Primary Gold Limited – Environment Impact Statement (EIS), 14A Amendment to the Toms Gully Underground Project Site - Modifications Reflective of Placing New Waste Rock and, Existing and New Tailings in the Pit

The Alterations and Changes from the EIS Supplement and this Section 14A for the Toms Gully Underground Project

Primary Gold Limited – EIS Section 14A Amendment December 2018

Figure 2: Modified Toms Gully Underground Project site layout (to be submitted as part of the EIS Addendum to the Supplement).

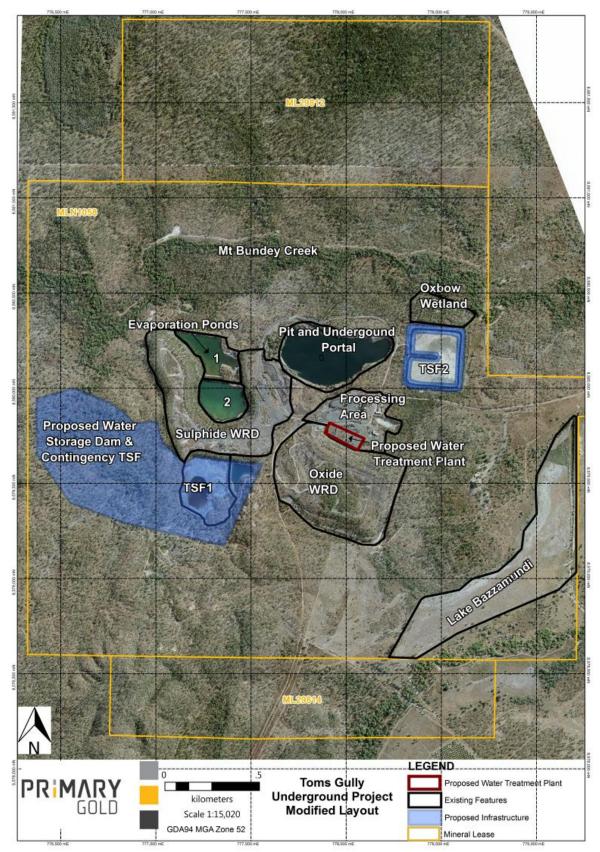
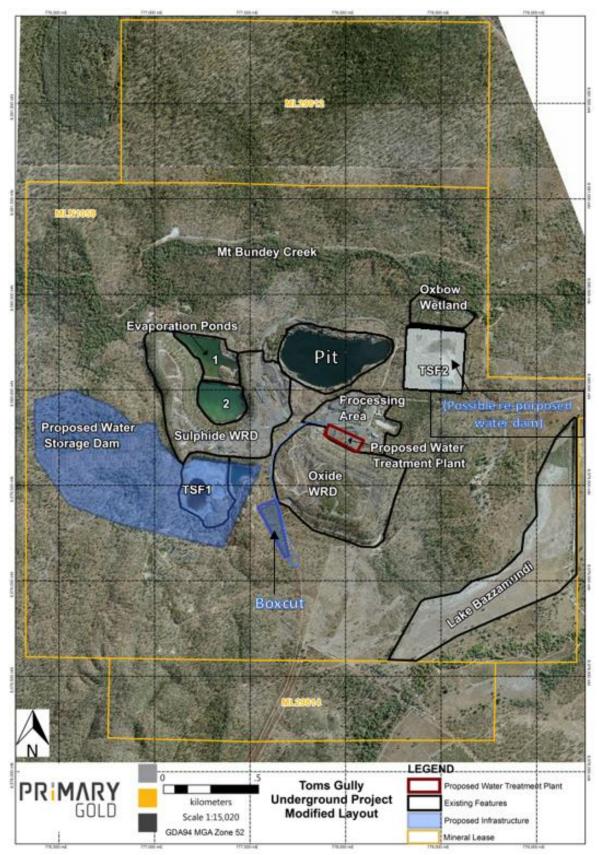
Details of the existing proposal can be located in the previous Draft EIS (dated 21 September 2018), Section 14A (dated 8 June 2018) and EIS Supplement (dated July 2018). This section will be limited to a discussion and comparison of the intended alterations. The proposed changes to the footprint of Toms Gully Underground Project are outlined in Figure 1 (EIS Supplement layout) and Figure 2 (revised layout).

Construction of a Boxcut (two hectare in area) and associated decline to access the Toms Gully ore body further down trend/dip. A Boxcut removes the requirement to enter the ore body via the existing Toms Gully open cut pit and underground workings.

- 8. Remove the need for the proposed contingency TSF that covers a 9 hectare area as all tailings will be placed in the pit.
- 9. Treat pit water insitu by the addition of lime or caustic or Virtual Curtain to lower the pH and remove metals from the water column.

Figure 3: Proposed Boxcut Positioned Down Dip of the Ore Body.

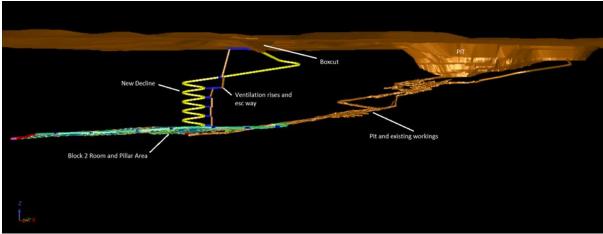
To access the ore, a Boxcut is to be located south east of TSF1 in an area of disturbed ground Figure 2. The portal and decline are located west of the near vertical fault called the "Crabb fault". Also the bottom of the Boxcut will be founded in fresh rock allowing the portal to be within stable ground conditions. Positioning of the decline negates having to transverse the fault, making development of the decline safer and easier. A 100 metre rock barrier pillar (i.e. Exclusion Zone) will be left (Figure 4). This rock barrier provides both horizontal and vertical separation between the two workings to allow the retention of pit water and positioning of the tailings and waste rock into the pit during operations.

Figure 4: Proposed Underground Workings Relative to the Barrier Pillar.

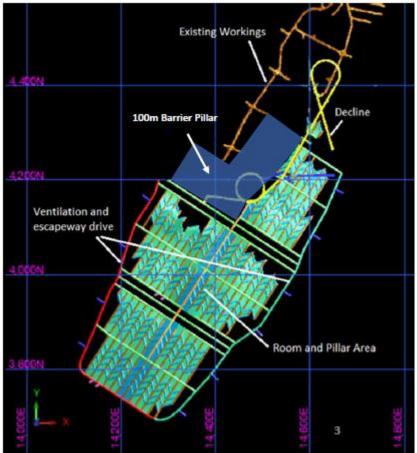
- 2. Leave a 100 metre rock barrier pillar (i.e. Exclusion Zone) between the old underground workings and the proposed underground working.
- 3. Placement of all existing and future tailings into the Toms Gully pit under the existing pit water level (i.e. under a water blanket) using a floating head system. The system is proposed to discharge the tailings deeper in the water profile to avoid oxygenated water. Tailings will be placed in the pit whether processed or not.

Figure 6: Cross Section Illustrating the Indicative Positioning of the Waste Rock and Tailings in the Pit.

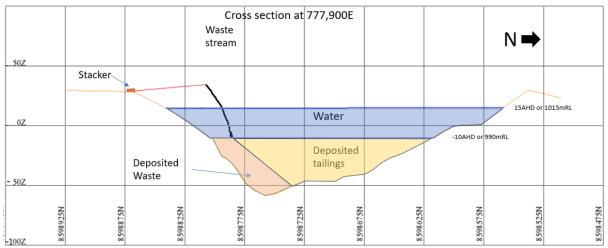
Primary propose to use a hopper and conveyer system ("Stacker") to drop waste rock approximately 60m from the pit edge towards the middle of the pit. The waste will fall through the water column and hit the wall where the pit slopes are steepest allowing the waste to slide to the bottom of the pit. The stacker is a mobile conveyer that is available with telescopic versions that can reach distances of 60m. Figure 5 and 6 below show the waste tipping method of a Stacker and final position of backfill material.

The mode of operation is to truck the waste to the Stacker over a 24 hour period. Waste is loaded daily into the Stacker hopper and the waste is transported to end of the Stacker conveyor belt and dropped into the pit at a distance of 60m from the pit perimeter. Due to the forward velocity of the material as it leaves the conveyor belt there will be an additional distance beyond the length of the conveyor that waste rock is thrown (estimated at least 5m). Through this process waste rock will be in the pit within 48 hours.

Figure 7: Comparison of Original Dewatering Volumes and Altered Dewatering Volumes.

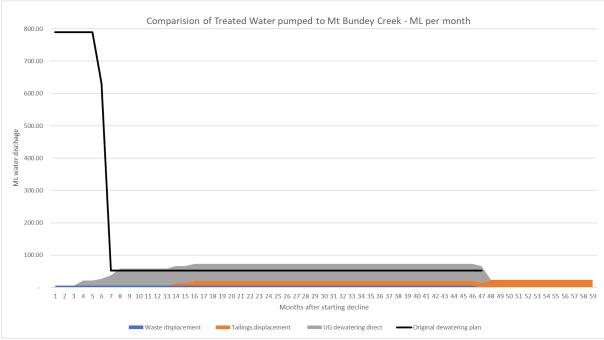
In the EIS Supplement it was intended to fully dewater the Toms Gully pit and remediate the underground workings to gain access to the Toms Gully orebody. To achieve this it was estimated that a total of 4.7 gigalitres of water would need to be removed and treated before discharge to Mt Bundey Creek, transfer to a third party and/or use across the site. To achieve the dewatering of the pit and water treatment it was expected to take 200 days that would occur during the wet season and dry season. The amount of water to be disposed by either usage or discharge would be 272 litres per second. If all the water was only discharged to Mount Bundey Creek (assuming the Mount Bundey channel is 12 metres wide) the rate of discharge would fill the creek to an estimated 0.24m depth and flow at 0.09m/s assuming a uniform creek bed and a 1 in 500 slope. From these calculations it is

Under the new proposal by placing tailings and waste rock in the pit beneath the water level only the displaced water would need to be removed and treated. Compared to original proposal, only 27.6 litres per second or 11 times less water would need to be disposed of by either usage or discharge. This maximum discharge is attained 16 months after underground development starts allowing for a stepped increase in treatment capacity compared to the rapid dewatering and discharge associated with the previous proposal. Figure 7 provides a comparison of the nominal discharge volumes. Note this figure provides a worst case scenario as it assumes all water goes to Mt Bundey Creek does not take into account water usage by the process plant or third parties. The greatly reduced discharge volumes result in a reduction the water depths and flow rates during the early part of operations in Mt Bundey Creek during both the wet and dry seasons

Figure 8: Nominal Water Volumes to be Treated during Operations.

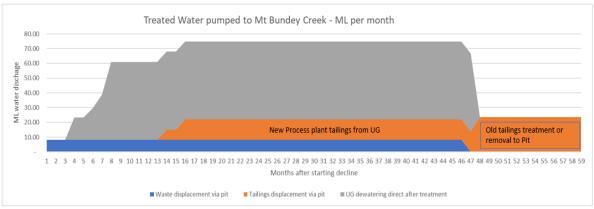
The proposal does not change the amount of dewatering required during operations. Figure 8 details the nominal volumes of the combined dewatering and water displacement that will require treatment and disposal. This figure provides a worst case scenario as it assumes all water goes to Mt Bundey Creek and does not take into account water usage by the process plant or third parties.
